Declaration on model difference

产品差异声明

Production name 产品名称	Trade name 商标	Model no. 型号	Description 差异描述
2.1CH Soundbar with Wireless Subwoofer, Wireless Subwoofer	Hisense	HS217F, HS217G, AX2107G, AX2107G+, AX2105A, AX2105B, AX2105C, AX2105F	Everyone of models has three schemes (A, B, C), the differences in AMP PCB, Touch PCB and Power Supply.
2.1CH Soundbar with Wireless Subwoofer, Wireless Subwoofer	TOSHIBA	TS217F, TS217G	Everyone of models has three schemes (A, B, C), the differences in AMP PCB, Touch PCB and Power Supply.

Scheme A

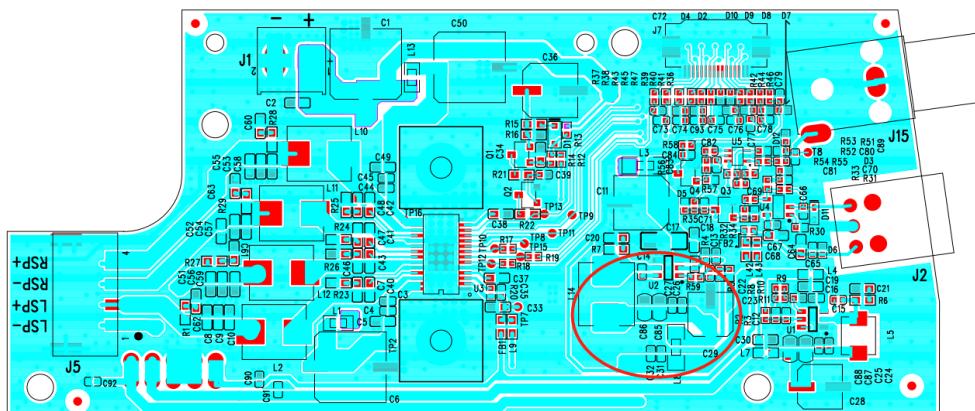
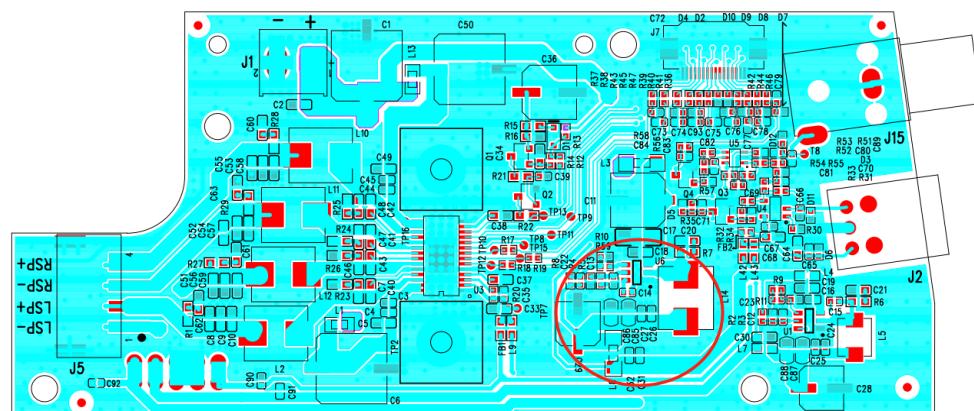
AMP PCB: Scheme A and Scheme B difference in Step Down Converter IC. Scheme A, B and C have the same circuit.

Scheme A: IC model: EIC01563/A, 4.2-17V

Scheme B: IC model: EIC01301, 4.5-24V

Scheme C is same as Scheme B.

Scheme A

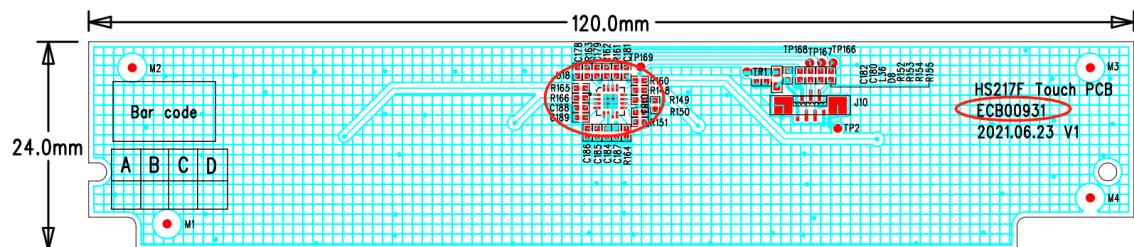
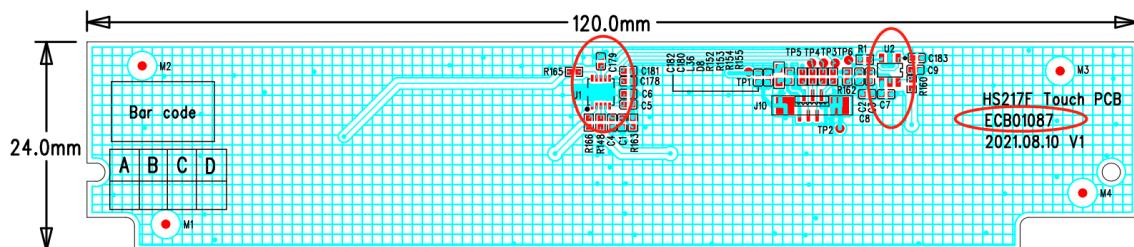
Touch PCB : Scheme A and Scheme B difference in Touch IC. Scheme A, B and C have the same circuit.

Scheme A: Touch IC model: EINQFMBR3108NS/A

Scheme B: Touch IC model: EIC00642, EIC01736

Scheme C is same as Scheme B.

(Manufacturer: AoYuan)

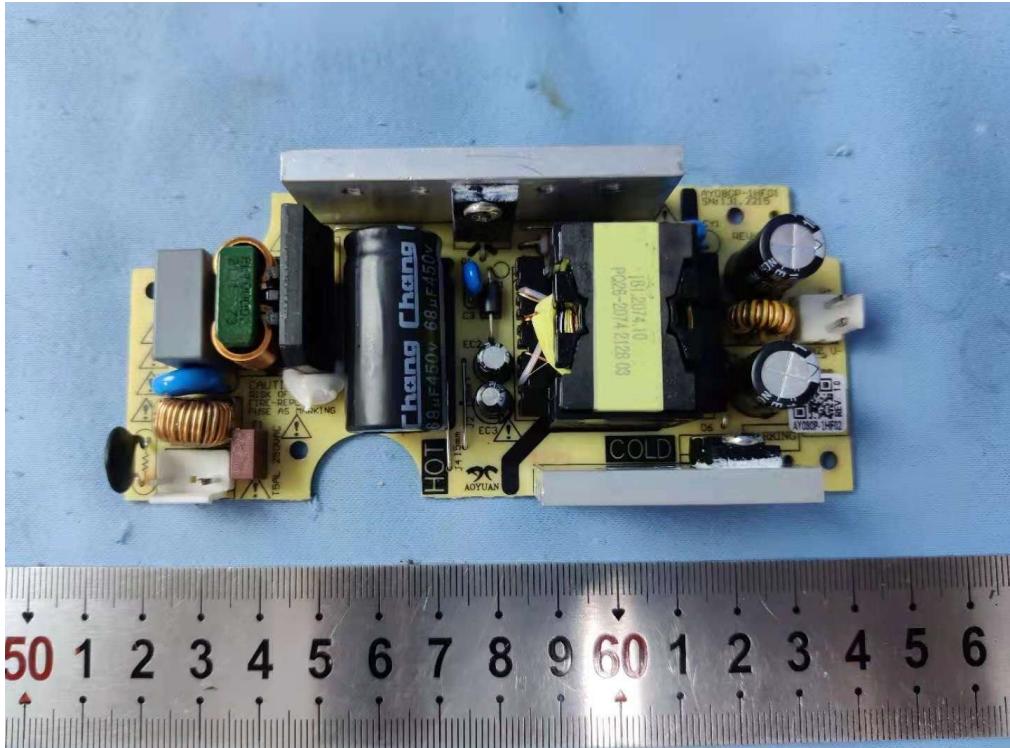
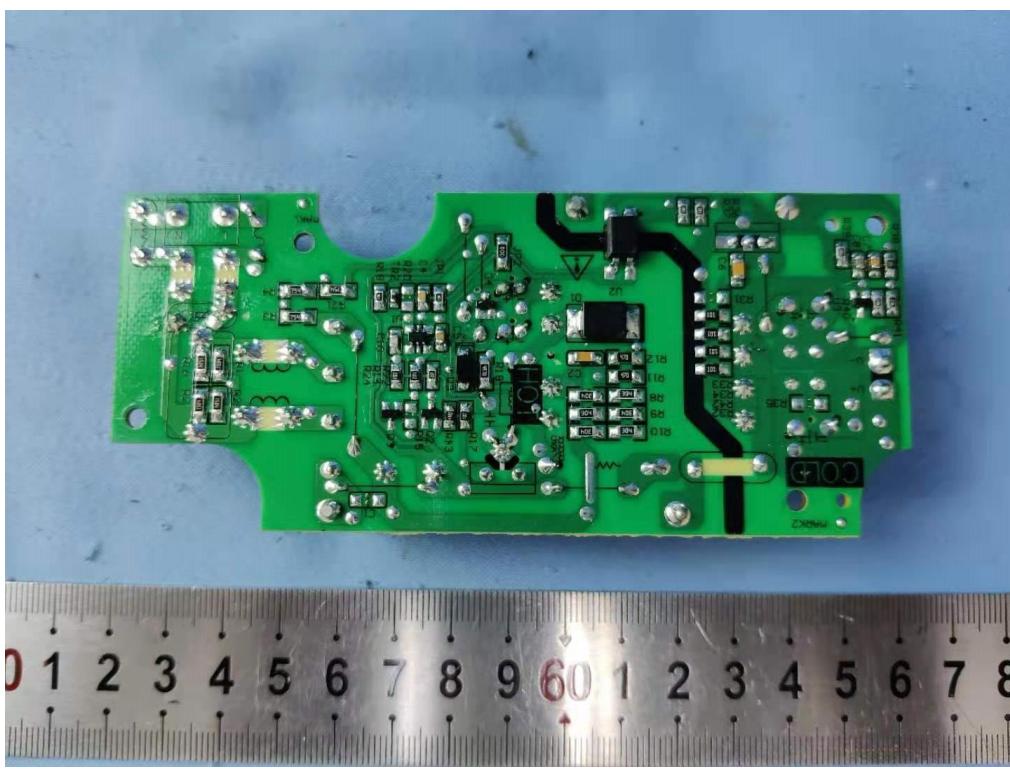
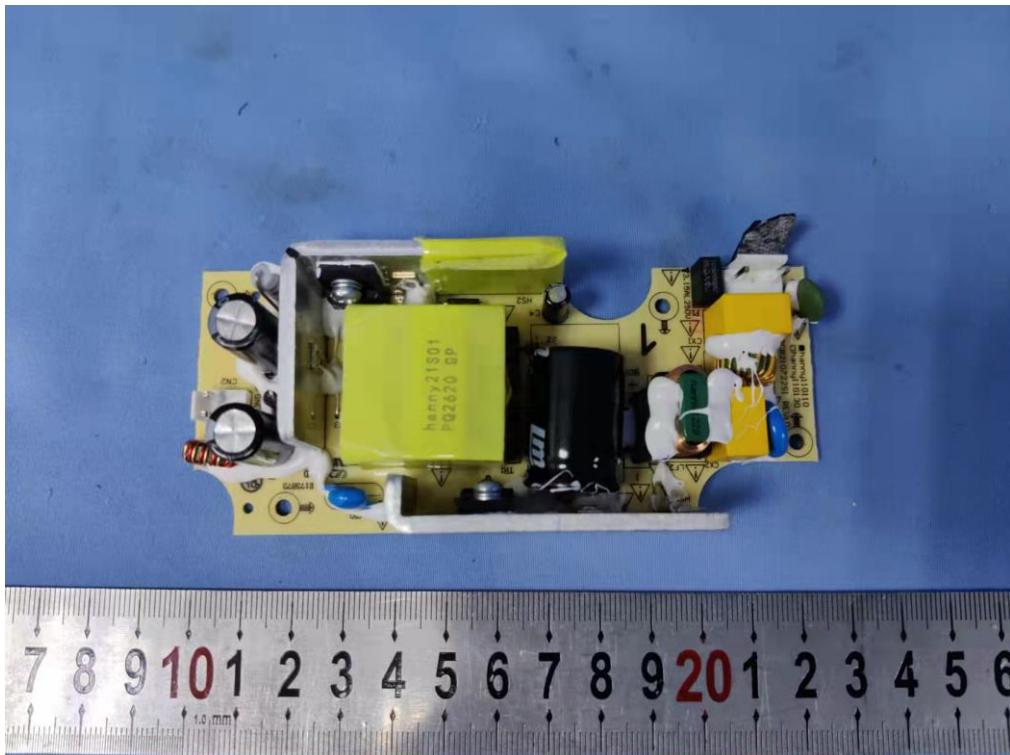
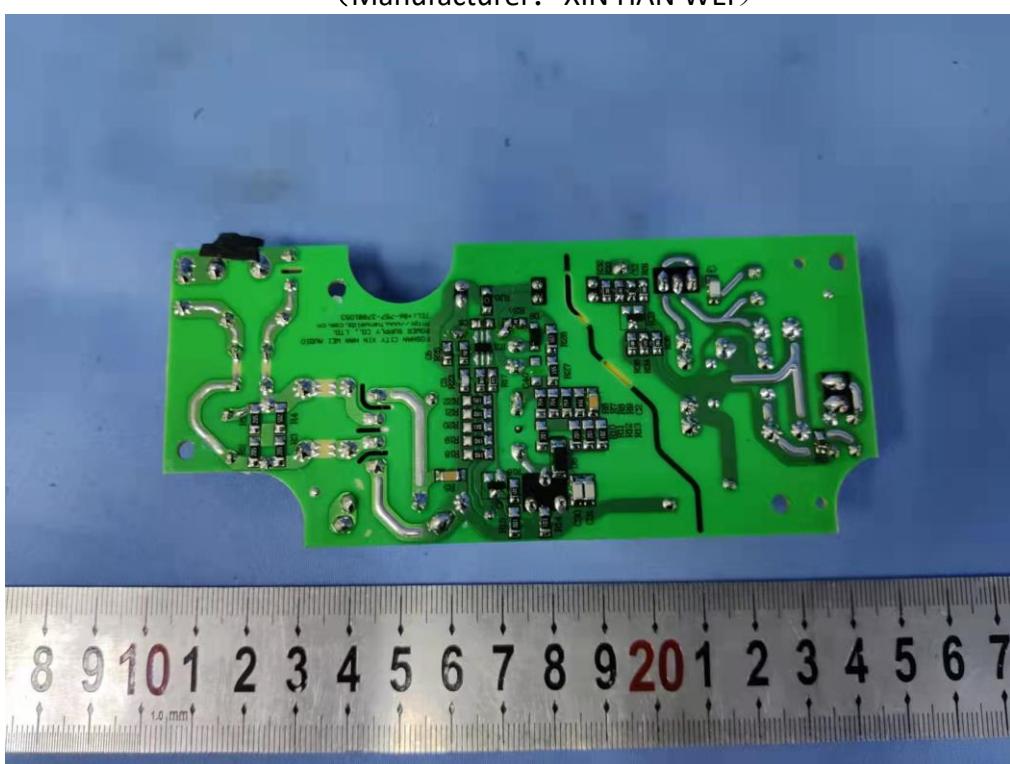
Power Supply: “AoYuan” and “XIN HAN WEI” are different power supply manufacturer.

Scheme A use AoYuan.

Scheme B use Ao Yuan.

Scheme C use XIN HAN WEI.
